APPENDIX R

Comments on the Draft EIS and Responses

Figure 1

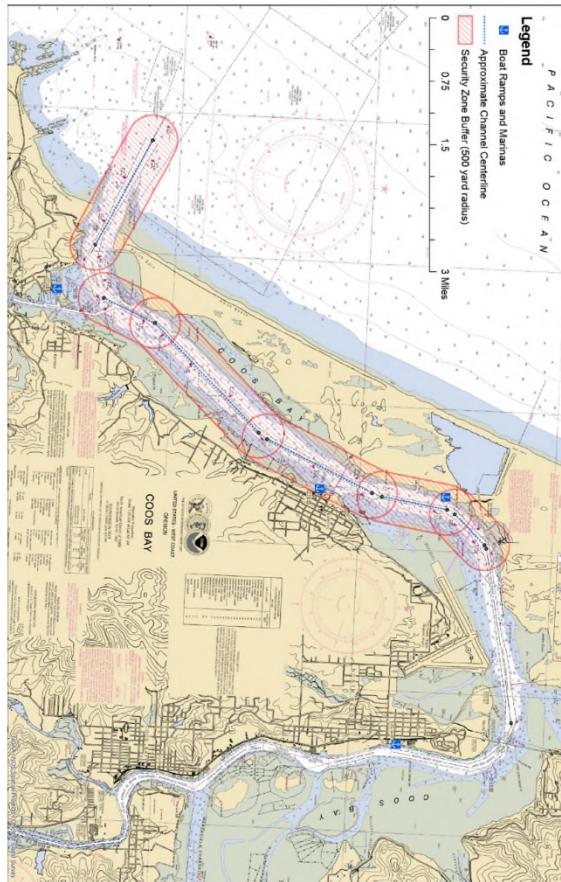
Topic	Sections/Pages	Missing from 2019 DEIS	Relationship to CZMA Analysis
Impacts of spatial restrictions of channel use to recreational and commercial fisheries. Please see Figure 1.	Section 4.8.1.1 JC Terminal Recreation and Visual Resources: Acknowledges impacts to crabbing/clamming, boating, and fishing because of LNG carrier security zone (pg 4-540-541) Section 4.9.1.7 Recreation/Tourism and 4.9.1.8 Commercial	Analysis regarding economic impacts from LNG carrier security zone requirements (i.e. missing preferred fishing times, tides, or other critical natural resource timing issues due to 2-3.5 hour delay (page 2-14) while LNG carrier is in navigation channel). The time estimation in Section 4.8 (pg 4-541) conflicts with information on pg 2-14 and also on pg 4-598 (20-30 minutes). Bar pilots guiding commercial ships report passing approx. 6 recreational boats (pg 4-541) and 2 commercial fisheries boats (pg 4-597) per trip. The width of carrier plus security zone (likely 500 yard radius around moving ship (pg	Coastal effects evaluation for impacts to local coastal economies from safety considerations and associated delays

SA2-372 Delays are estimated to be from 20 to 30 minutes as discussed in section 4.9.1.8 of the draft EIS. Section 4.9.1.8 has also been revised to provide more details regarding the Coast Guard safety and security zone for LNG vessels. Non-LNG vessels would be allowed to transit through the safety zone and would also be allowed in the safety zone during passage, provided that these other vessels do not impede the safe navigation of the LNG carriers in the restricted channel, and that the other vessels do not pose a security threat or concern to the LNG carriers in transit.
